## ADDENDUM NO. 1

TO: PLANS AND SPECIFICATIONS FOR STATE OF MISSOURI

*REBID, St. Clair Readiness Center-Renovate Interior & Exterior*  
375 S. Commercial Ave., St. Clair, MO 63077  
PROJECT NO. T232601

INTERIOR FINISH  
SCHEDULE AND  
LEGEND

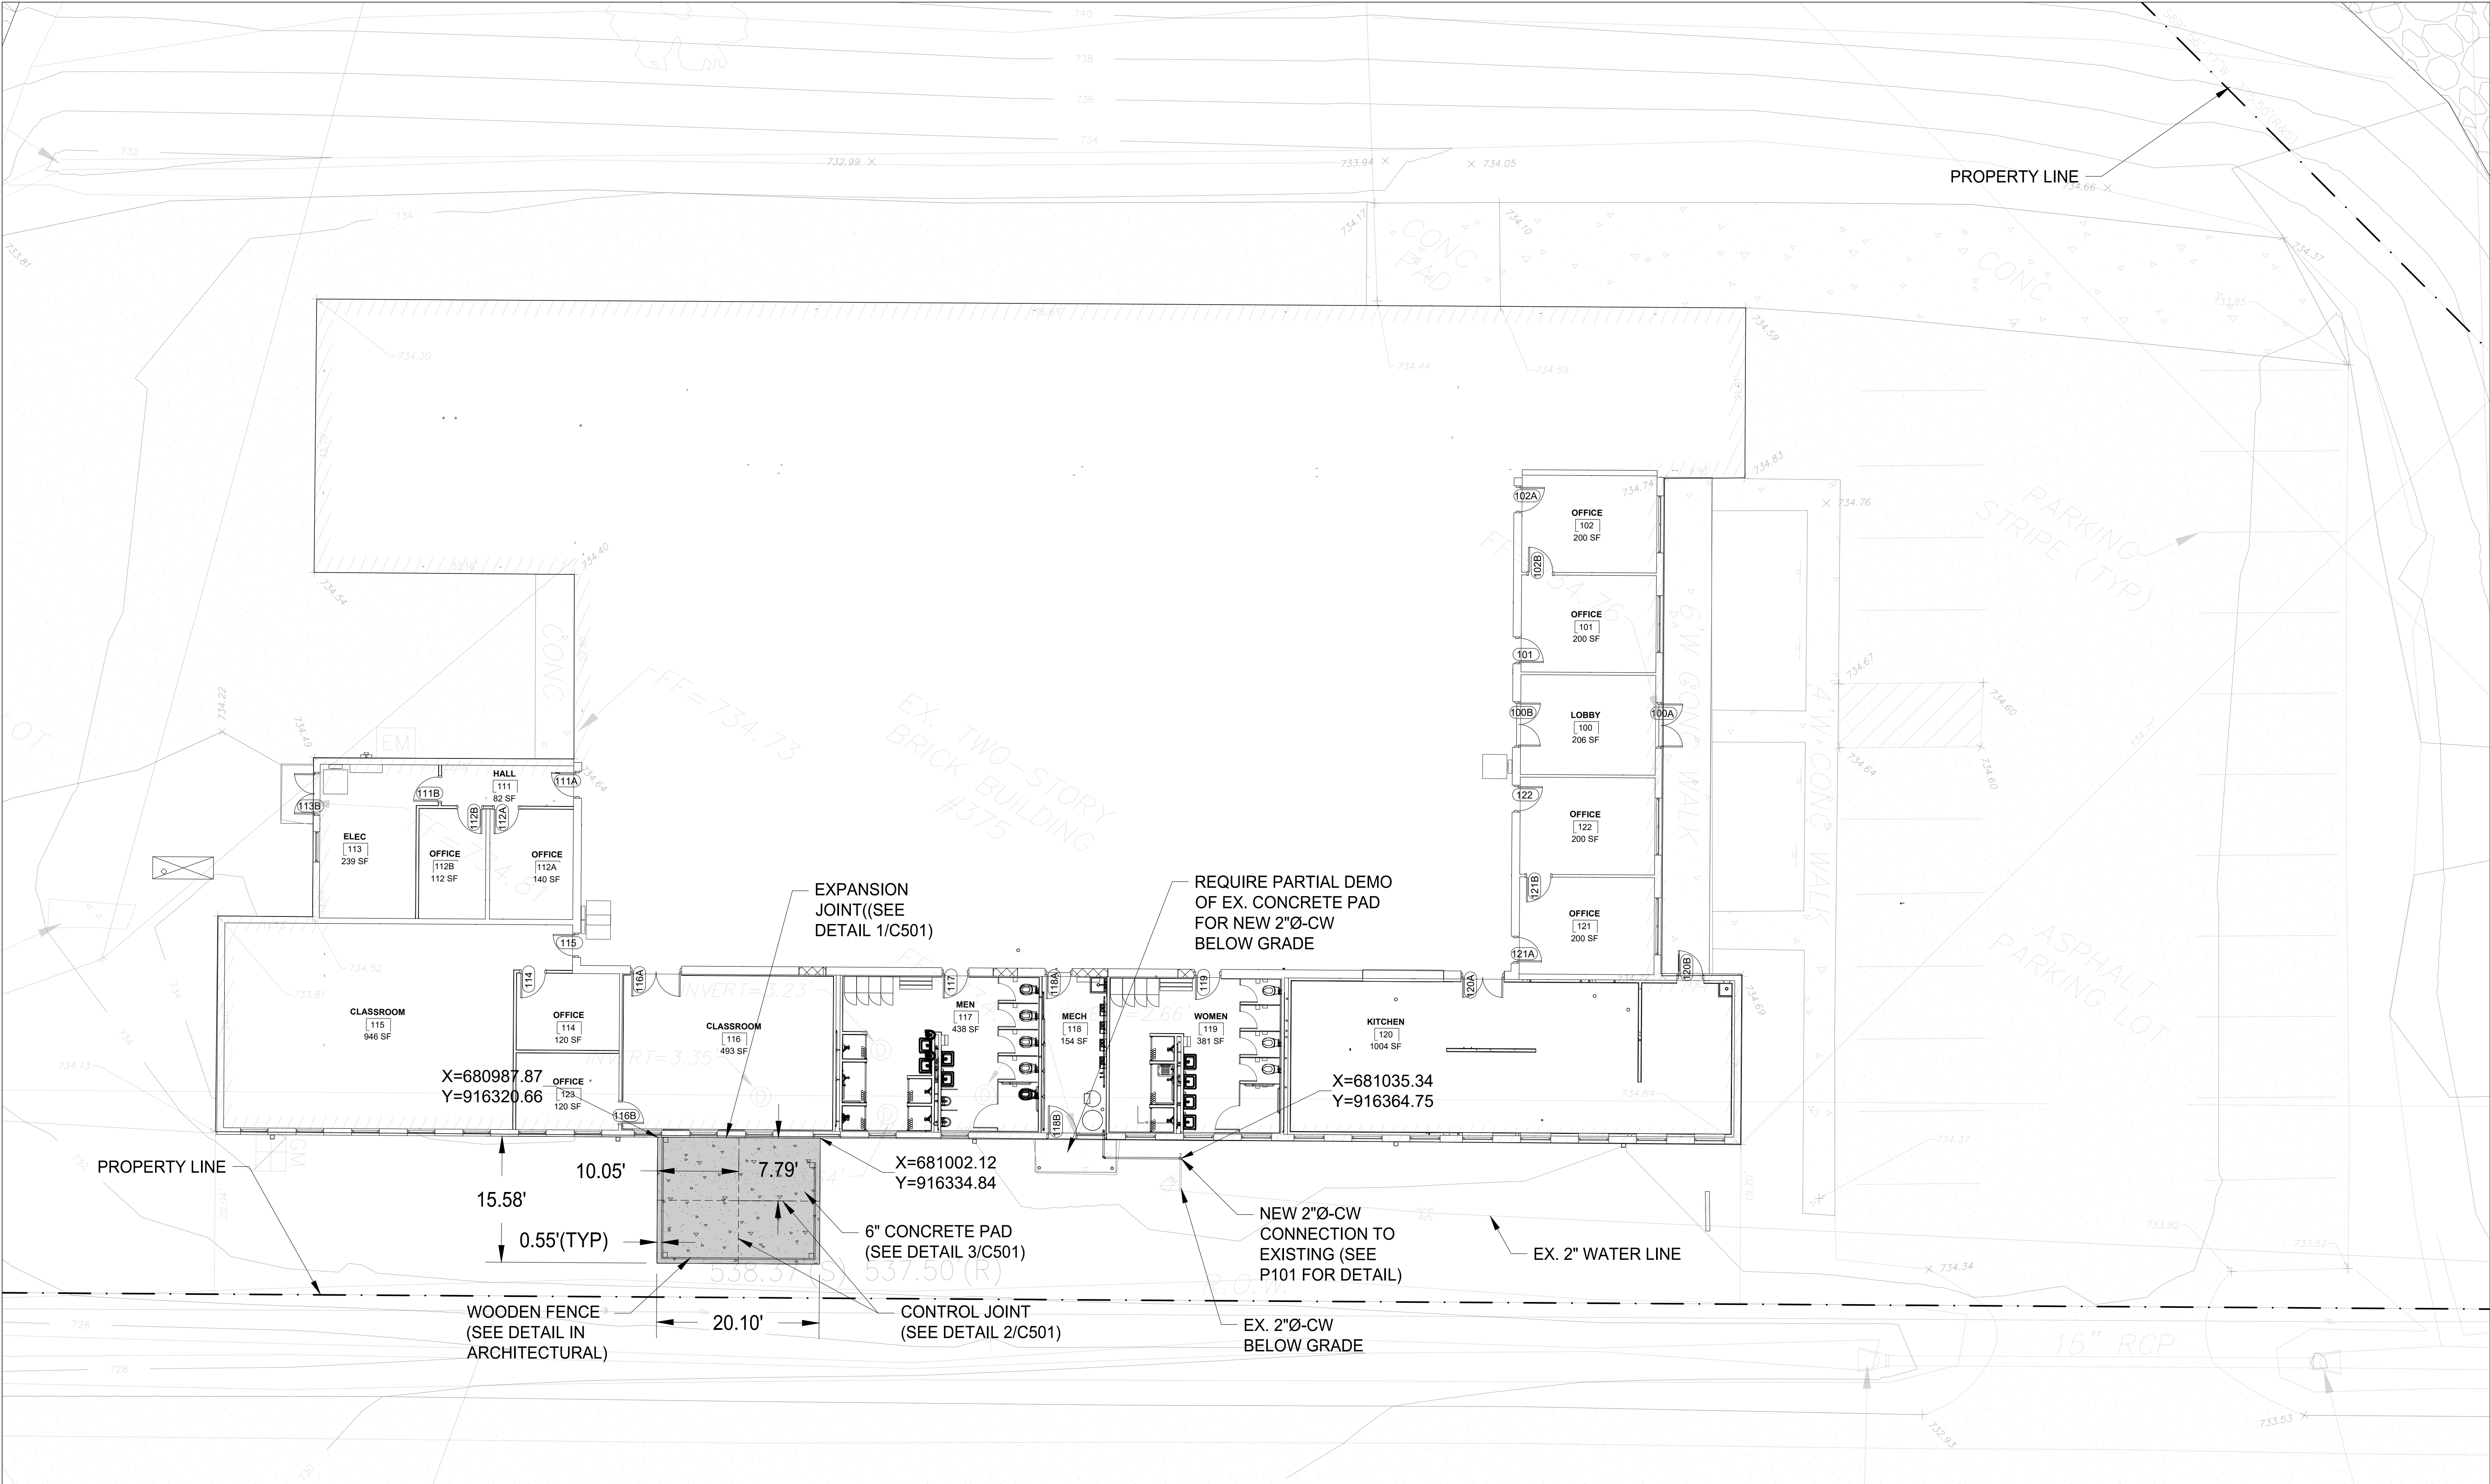
4. Sheet A800 has a room "Training Office 104 on finish Schedule, but it is not located on Sheet A810, Finish Plan. Do you have any ideas?
  - a. The room Training Office 104 is no longer in scope. Sheet A800 has been updated

- a. Per the Asbestos Inspection Report - "All quantities are to be verified by any contractor bidding for the removal".
29. Spec Section 033543 – Polished Concrete indicates all specified floors to be grinded, polished, and stained. Whereas inside the Drawings indicates on A 800 Finish Schedule, that specified rooms are to have sealed concrete. With there being no spec section for sealed concrete, this makes us question if this is supposed to be Polished Concrete? Please Specify.

- a. See updated interior finishes schedule in sheet A800
30. On Specification Section 035413 Gypsum Board Underlayment can you provide a detail or drawing that indicates where this is to be installed at?

2 ONE-LINE DIAGRAM - NEW

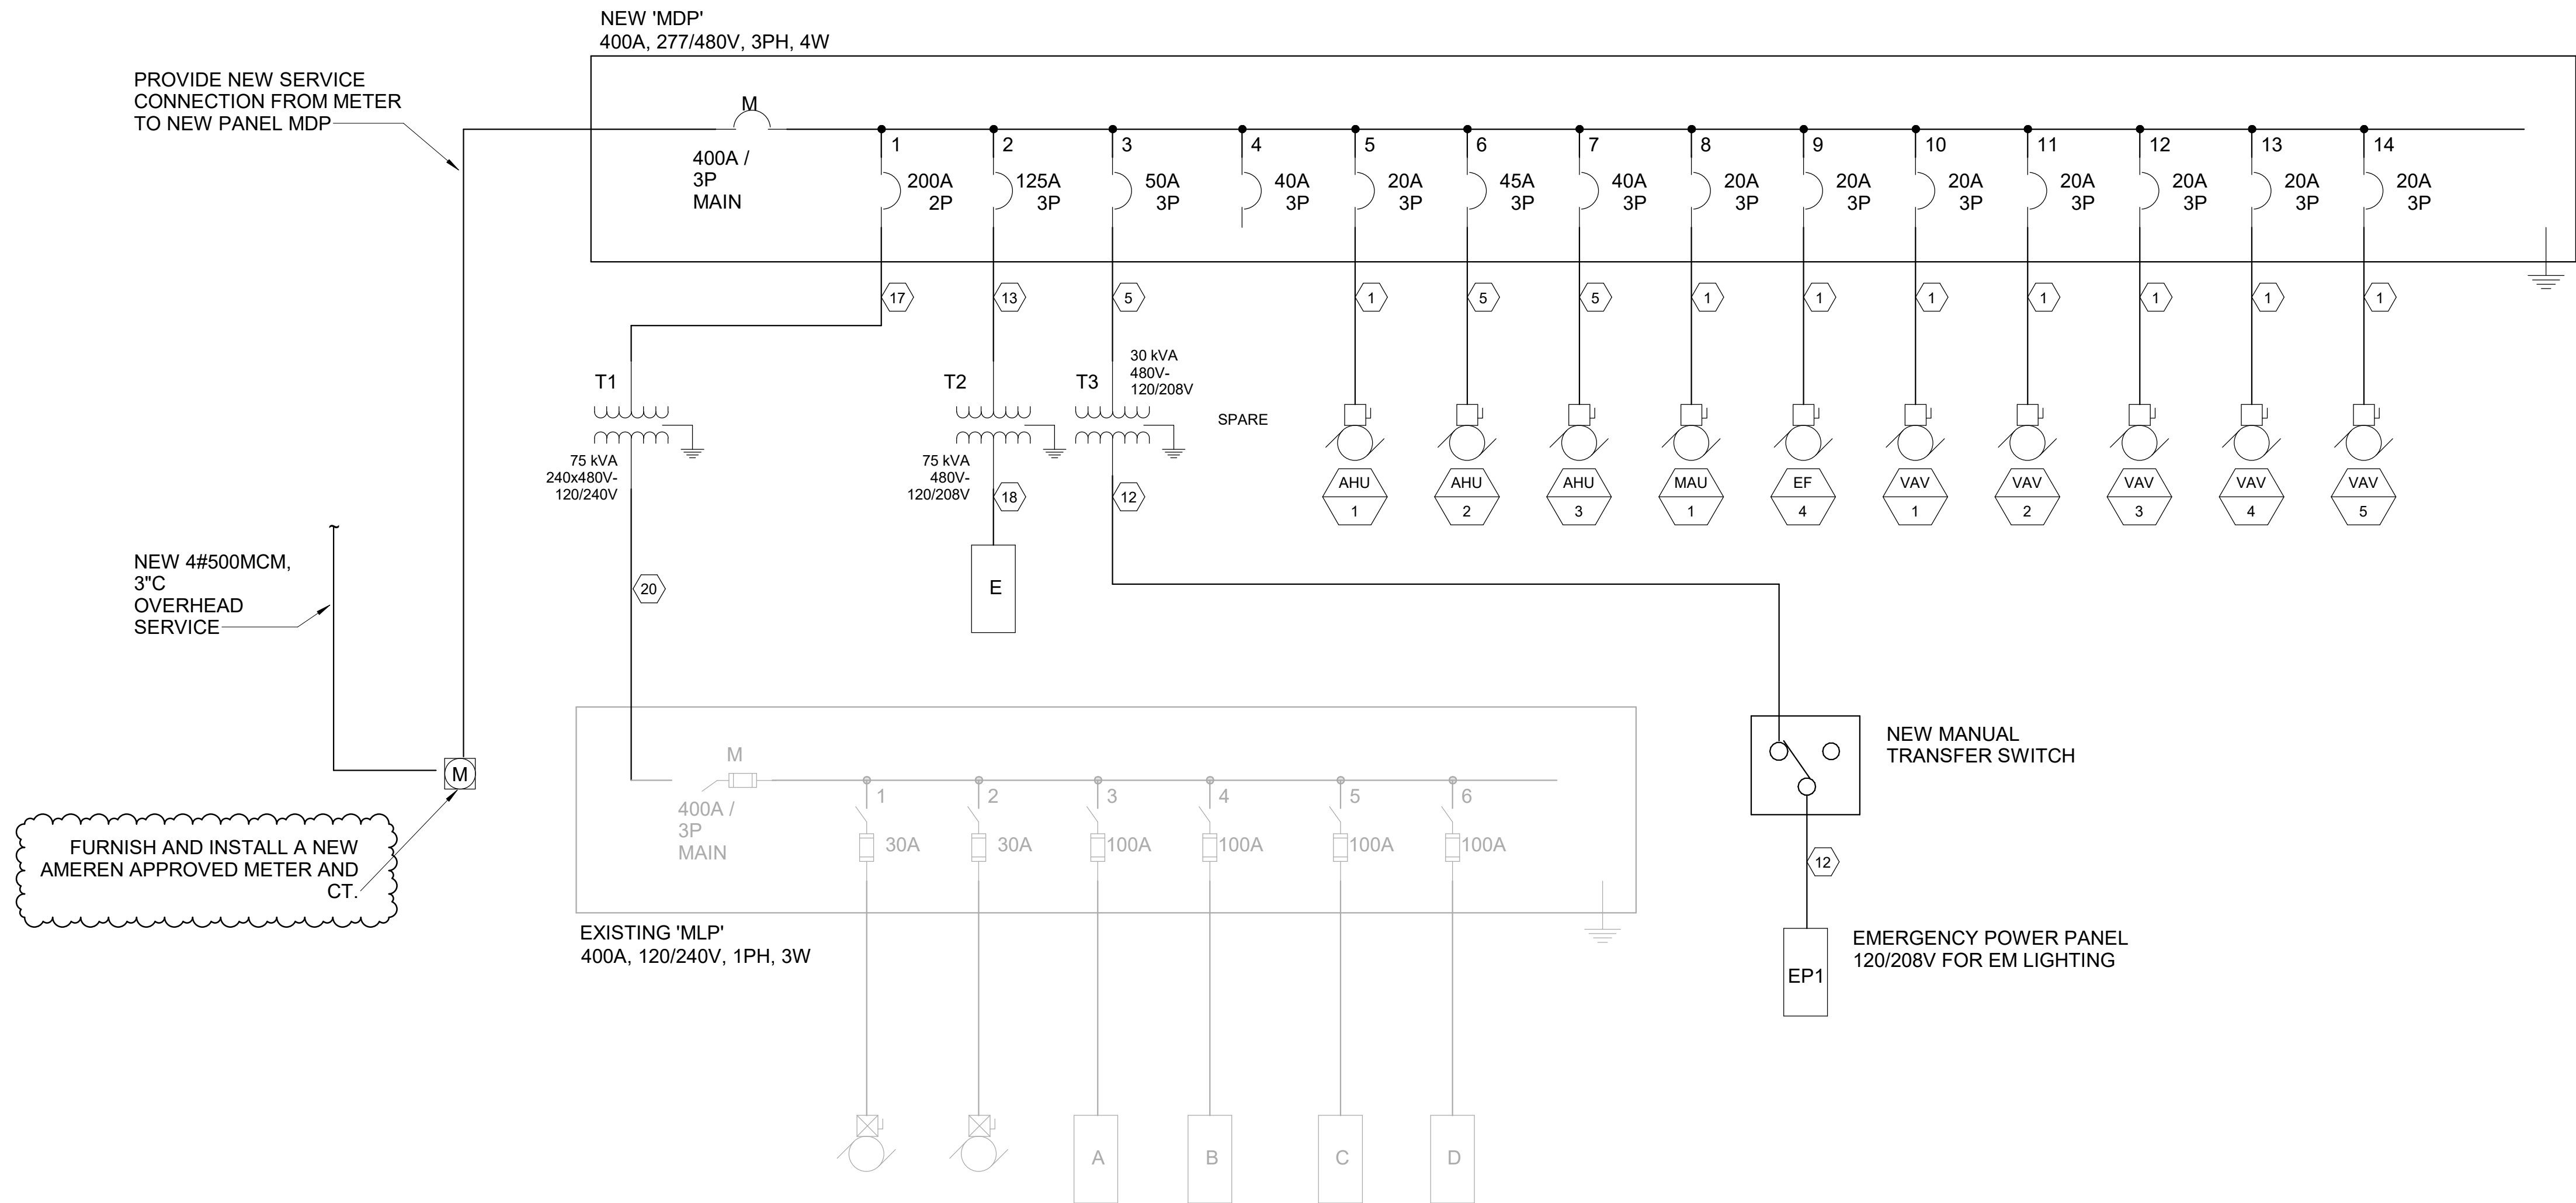
11. On the print it shows only new power from existing meter to new MDP (and adding an extra 500MCM for a 4-wire system). I know our power company (Ameren) now requires Cts/Pts on a commercial service 400 amps or more. Just want to verify your plan is to use the existing meter base and riser, or do we need to figure new meter base, CTs/PTs and raceway?

- a. Yes, new meter would be required, in reference to E701.
12. Who is responsible for the Third-Party Air Monitoring? The owner, GC, or abatement contractor?
